HIGH-RISE PRESUBMITTAL CONFERENCE (2018 SBC)

PROJECT INFORMATION		APPLICANT INFORMATION	
Project Name: 2005 5th Ave		Contact Person: Evette Yu	
Project Address: 2005 5th Ave		Contact Address: []	
Construction Application/Permit: # 6905849-PH		Contact Email: evette.yu@mza-us.com	
MUP Project: # 3028017-LU		Contact Phone: 214.929.2801	
Conference Attendees			
Name	Company	Phone	Email
Jenny Tsen	Chainqui Development		jenny.tsen@chainqui.com
Evette Yu	MZA		Evette.yu@MZA-us.com
Craig Davenport	MZA		Craig.davenport@mza-us.com
Don Koberg	Rushing		donaldk@rushingco.com
Tim Del Mundo	Rushing		timd@rushingco.com
Steven Huff	Rushing		stevenh@rushingco.com
Cameron Smith	Rushing		camerons@rushingco.com
	JTM

44-story, 500-unit apartment building with ground floor retail and 3 levels of office at the corner of 5th Ave and Virginia.

TYPICAL PLAN FOR L2-L6

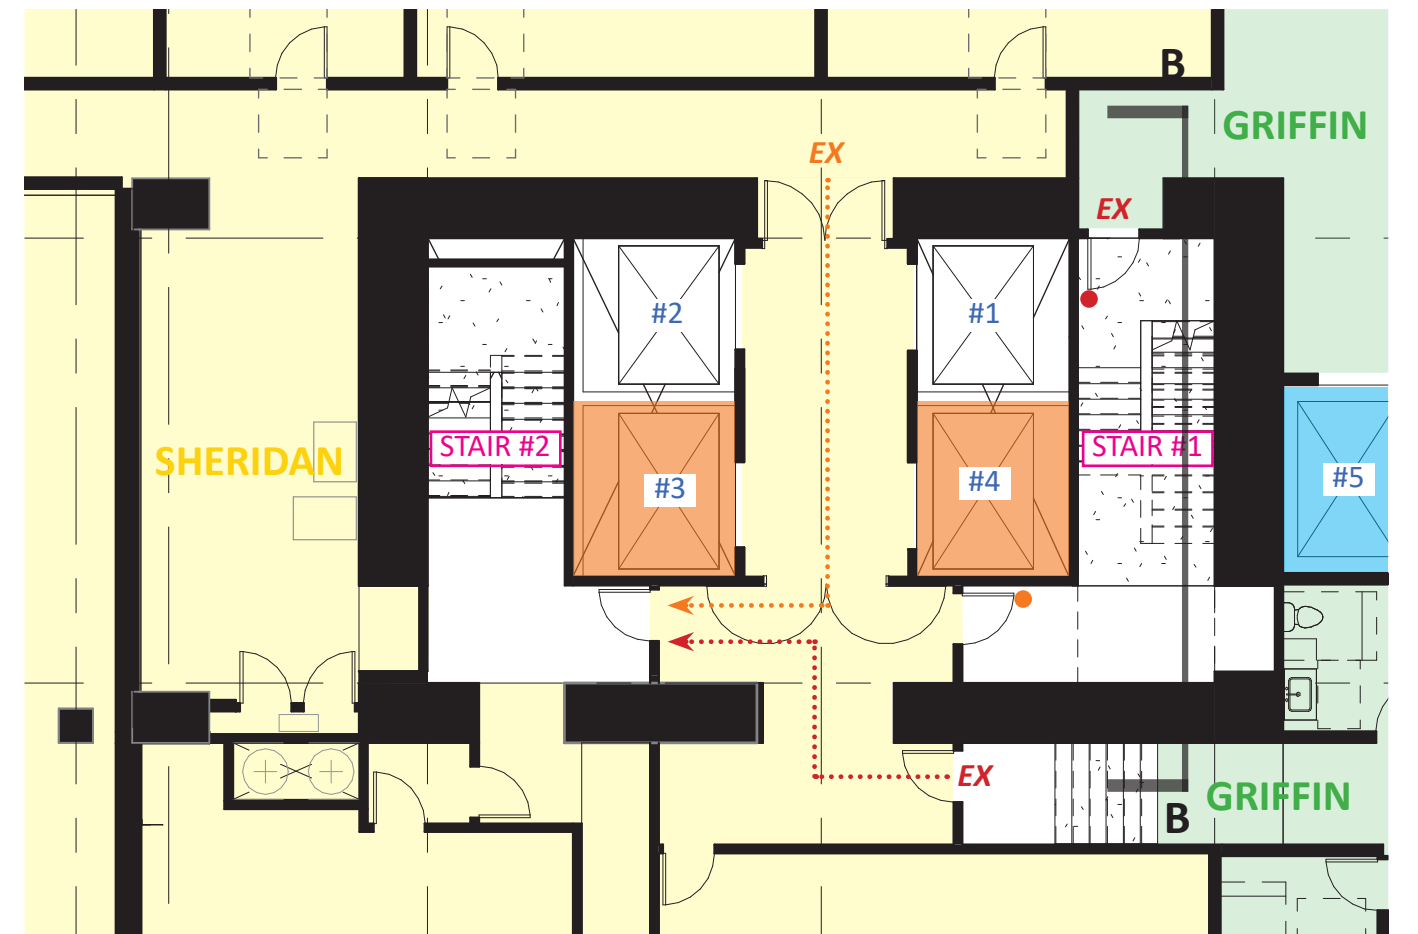
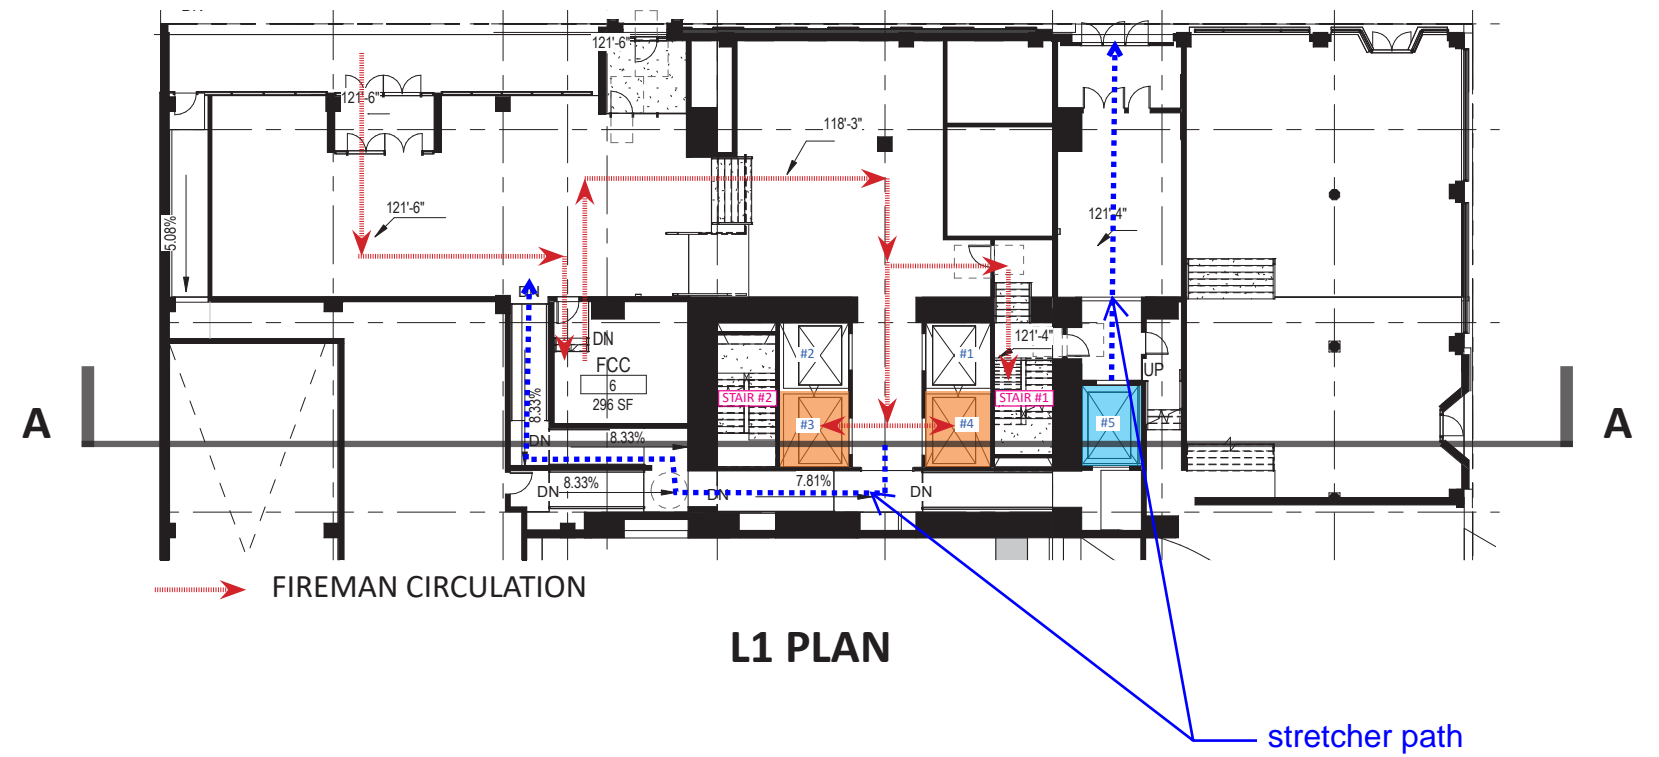
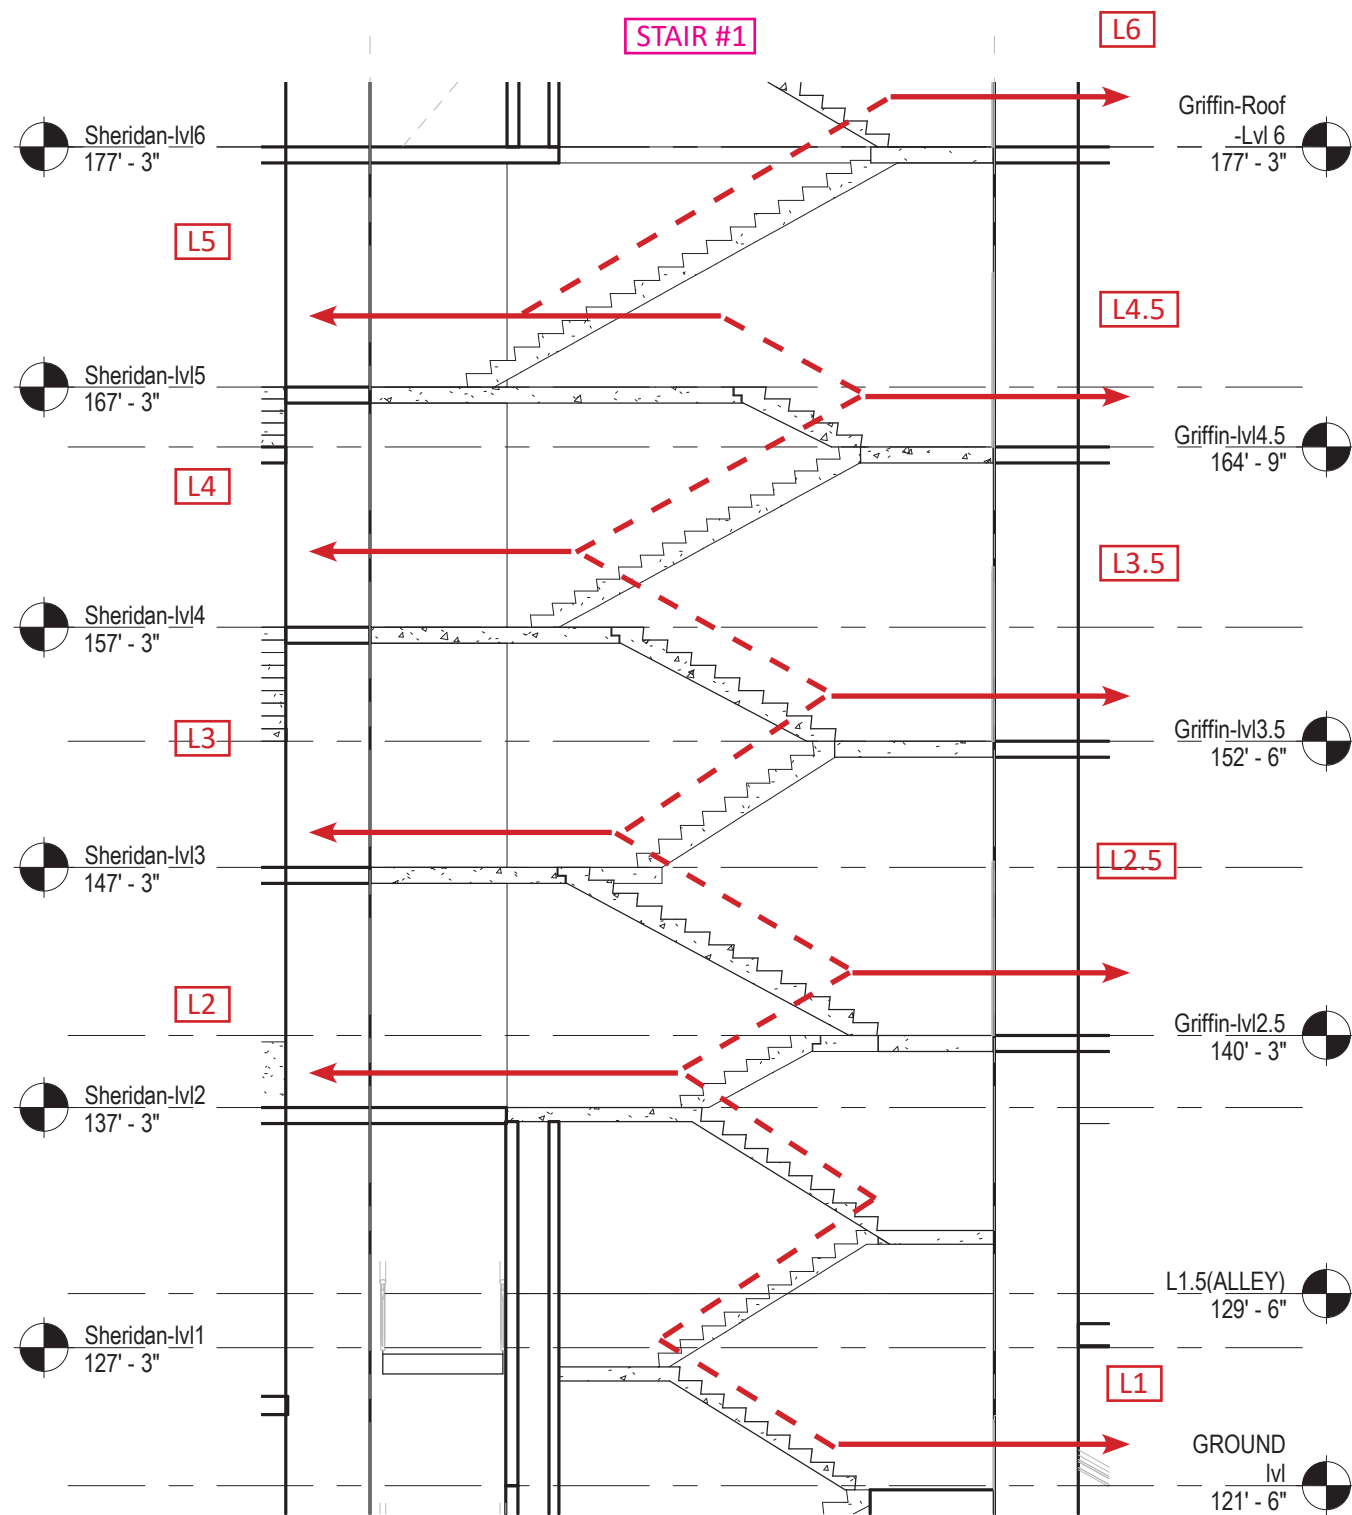
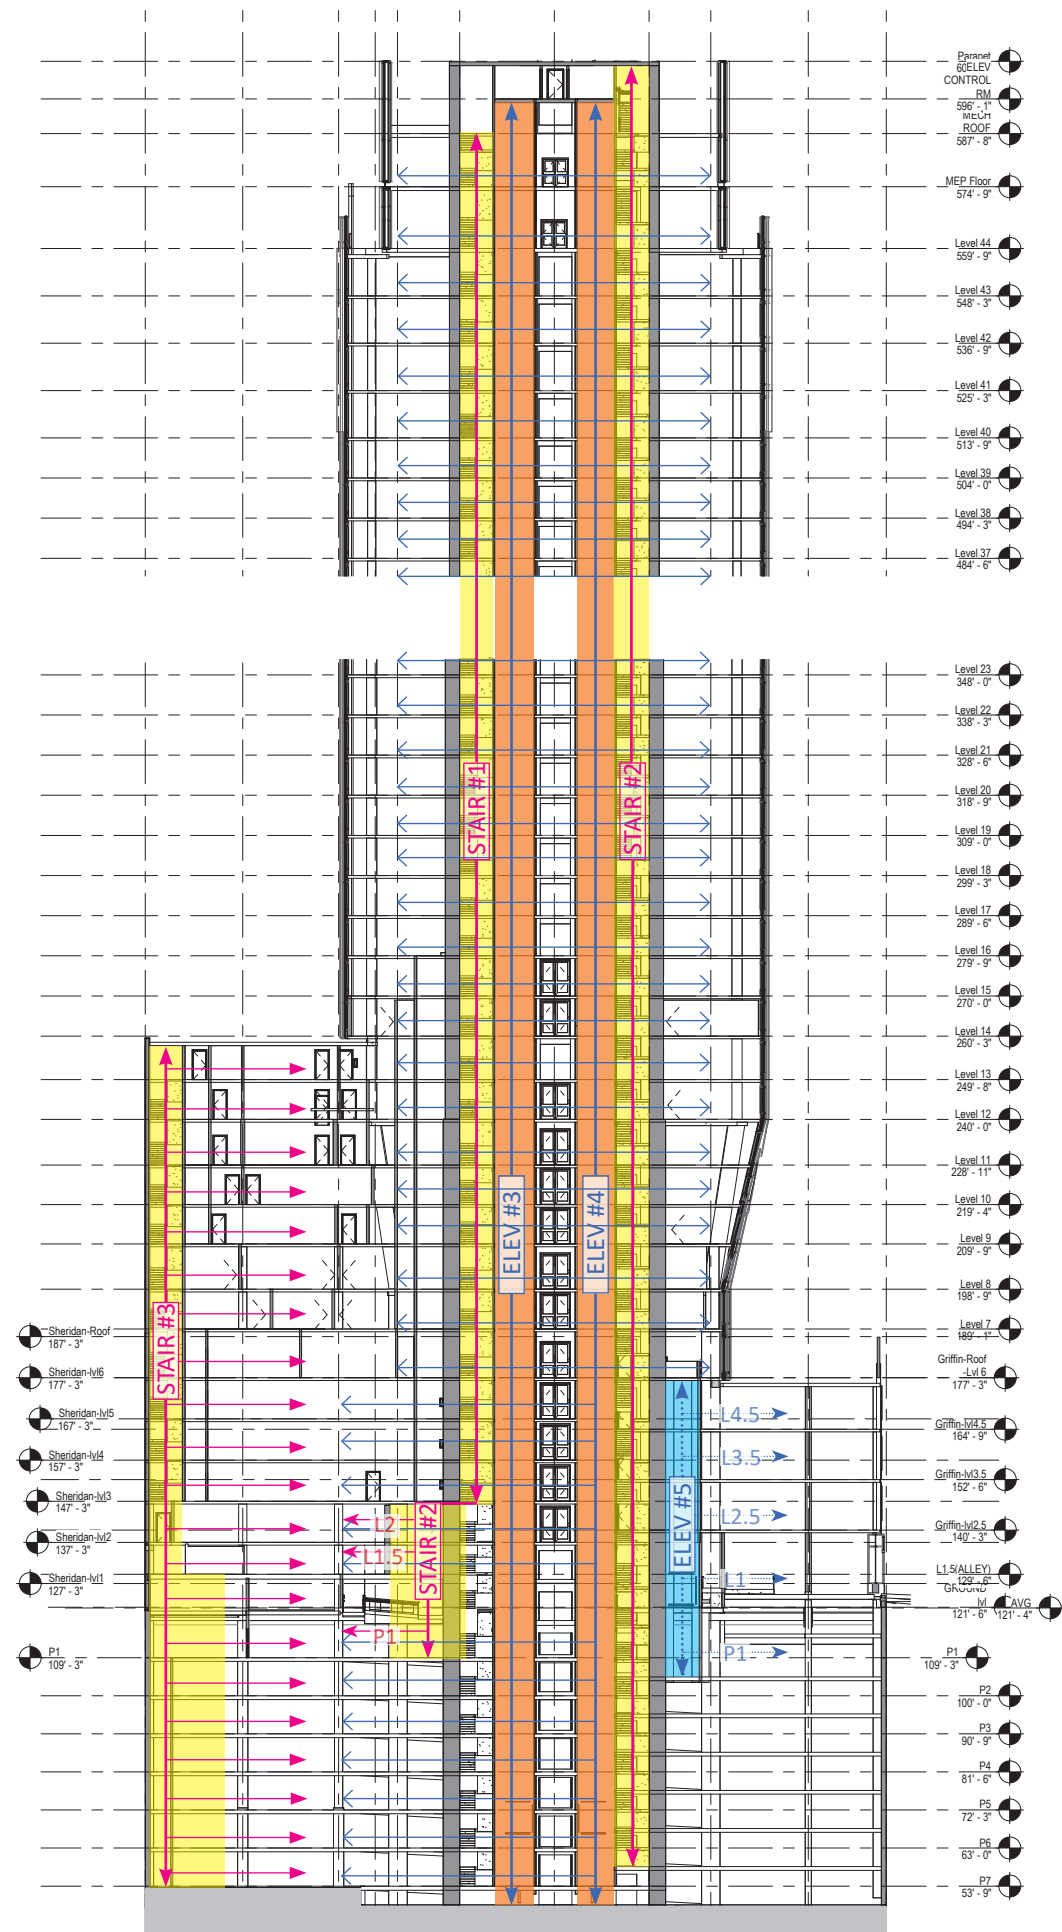
<p>Proposal: (RUSHING)</p> <p>No exception taken.</p>
Conference discussion & decisions:	
3020.1* & 3020.4* Construction of Hoistways, and machine and control rooms	<i>Key Items: Construction of hoistways and hoistway enclosures shall comply with ASME A17.1 Section 2.1 as amended.</i>
	<p>Proposal: All elevator hoistway will be 2-hr fire barrier. Elev Control room to be 1-hr fire partition. No exception taken.</p>
Conference discussion & decisions:	
OTHER	
Other	<i>Describe any significant interpretation requests or special conditions you wish to address including any issues requiring a code alternate or code modification.</i>
Code Alternate/ Modification <input type="checkbox"/> (form attached)	<p>Proposal:</p> <p>1. Two landmark buildings on site and have different floor to floor height. the infill portion on the north matches the Sheridan building elevations. FSAE stops at the Sheridan building levels and access Griffin levels via stair#1.</p>

<p>Office elevator serves as the Accessible means of egress elevator for Griffin levels.</p> <p>2. Stair#1 has access to all levels via doors on east and west side of the stair enclosure.</p> <p>see page 15-17</p>
Conference discussion & decisions:

MECH ROOF PLAN

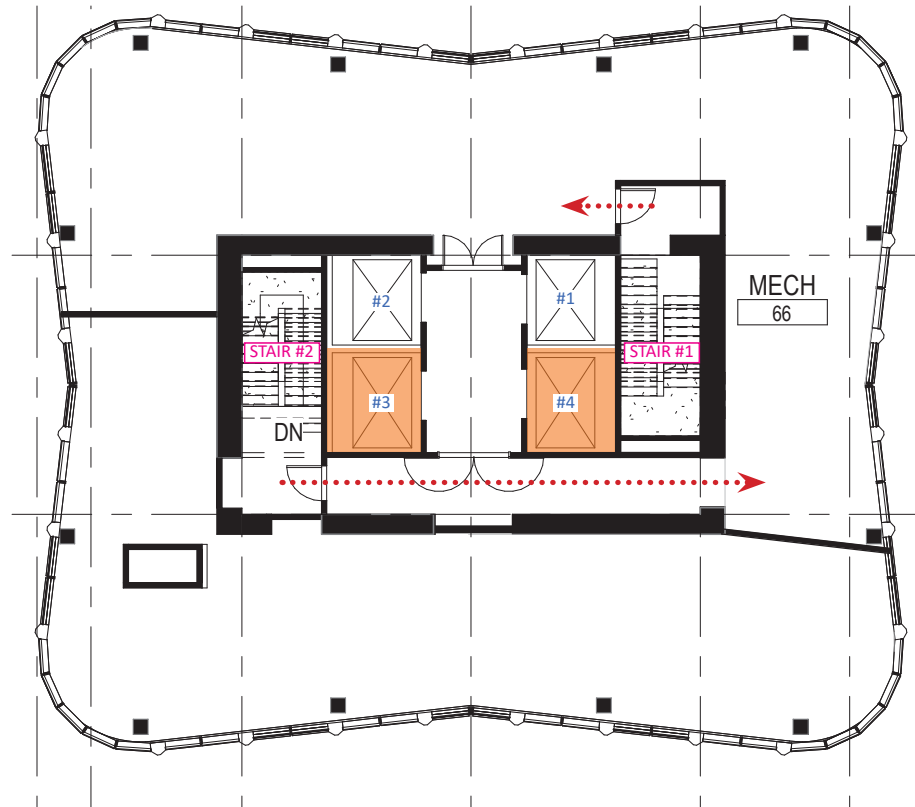
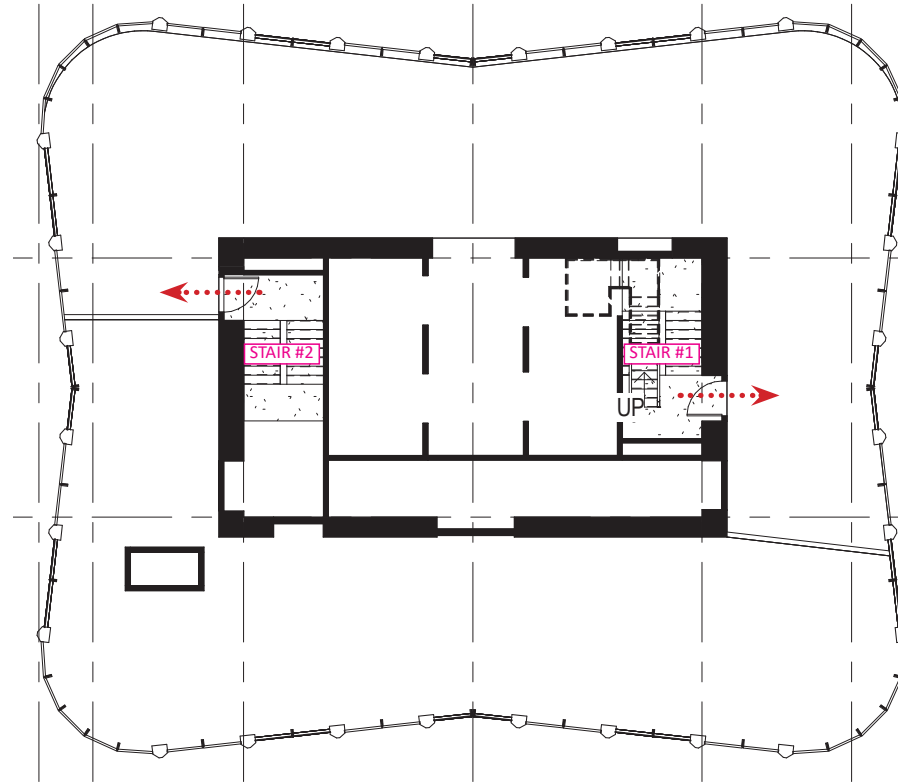
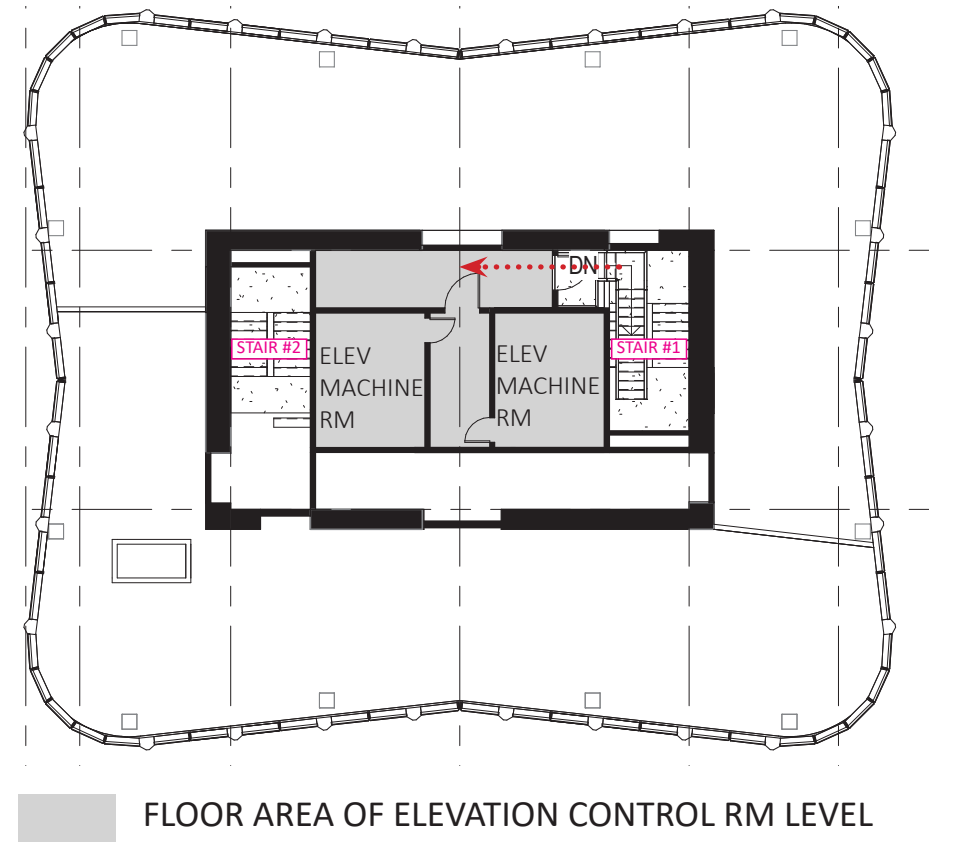
403.5.8* Stairway termination	Key Items: All required interior exit stairways shall terminate at a roof in a penthouse with a door complying with Sections 1010.1.1 and 1010.1.2. The building official is permitted to approve an alternate design at the pre-design conference. The intent is for all required stairways to have at least one door or approved penthouse alternate roof hatch that opens directly to the exterior on a roof level, and that all other roof levels may be accessed via stairs, ships ladders or alternating tread devices. See attached "Seattle High-rise Requirements for a Roof Hatch When Approved as a Penthouse Alternate"
	Proposal: Proposed approach is for both tower stairway to extend to the mechanical roof level with door opening on to the roof, and one stairway to stop at the Elevator machine control level with a roof hatch access the roof over Elev control room. Mech Roof and Elev Control room roof are considered non-occupied.
